UNITED STATES PATENT AND TRADEMARK OFFICE

APPLICATION NO.	FILING DATE	FIRST NAMED INVENTOR	ATTORNEY DOCKET NO.	CONFIRMATION NO.
10/769,151	01/30/2004	Nobuyuki Fujiwara	1339	9525

<p align="center">Office Action Summary</p>	<p>Application No.</p> <p align="center">10/769,151</p>	<p>Applicant(s)</p> <p align="center">FUJIWARA ET AL.</p>	
	<p>Examiner</p> <p align="center">Stephen A. Holzen</p>	<p>Art Unit</p> <p align="center">3644</p>

DETAILED ACTION

Fig. 1

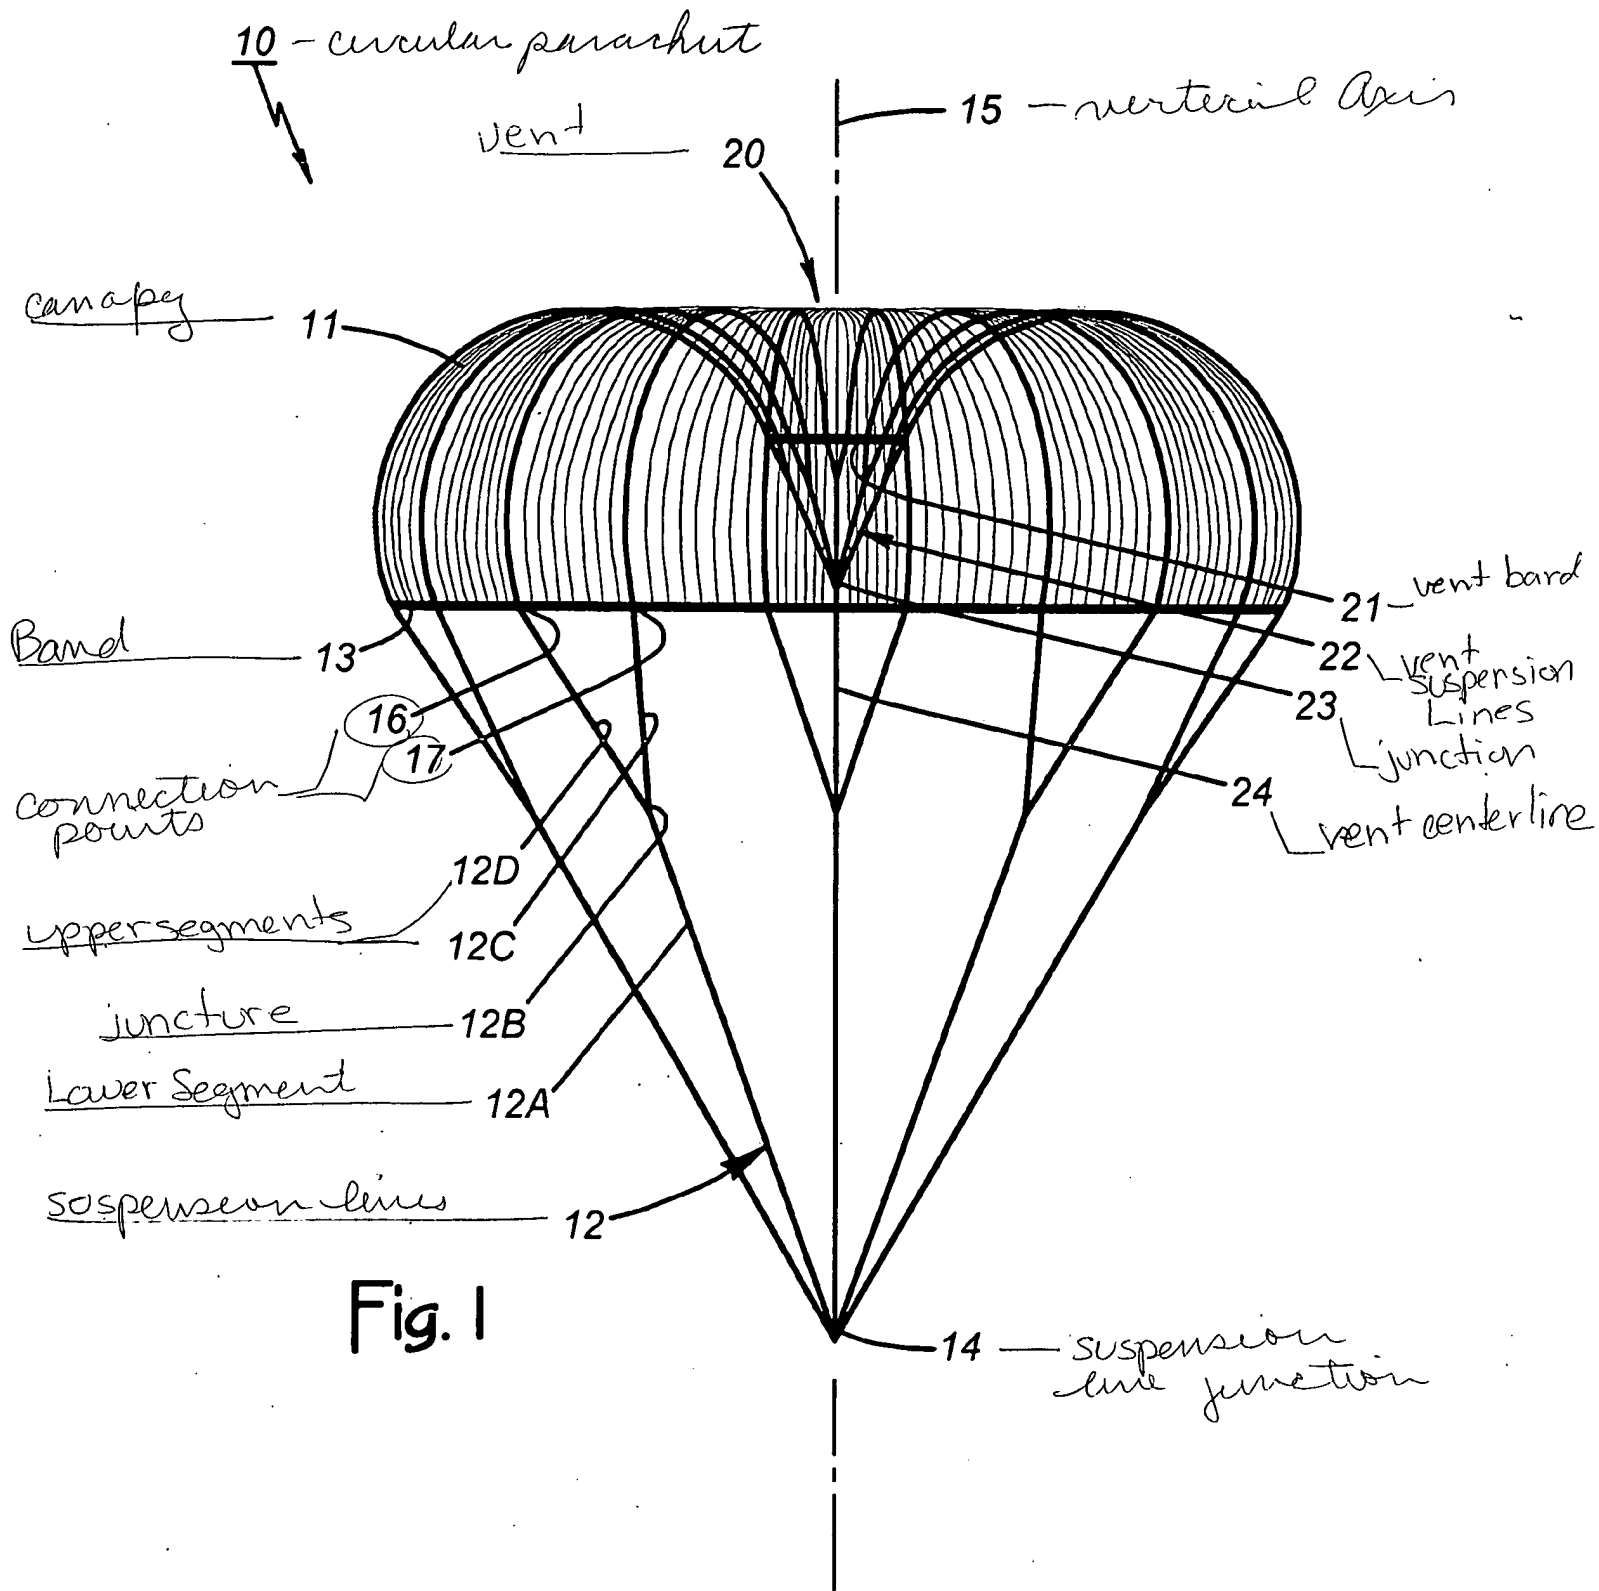
3. Claims 1, 2, 4, and 8 are rejected under 35 U.S.C. 102(b) as being anticipated by Sadeck (4,623,109). Sadeck discloses a parachute having a circularly shaped canopy (10) having a skirt band (3) and a plurality of main suspension lines (10 & 16) connected to the skirt band (3) wherein each main suspension line includes a lower main suspension line segment (16) that branches into at least two upper main suspension line segments (10) and wherein the upper main suspension line segments of each main suspension line are connected to the skirt band (see Figure 2), wherein the upper main suspension line segments have a common length (see Figure 1), further comprising a vent band (25) on the circularly shaped canopy and a plurality of vent suspension lines connected to the vent band (22), wherein each vent suspension line

includes a lower vent suspension line segment that branches into at least two upper vent suspension line segments (18 and 22).
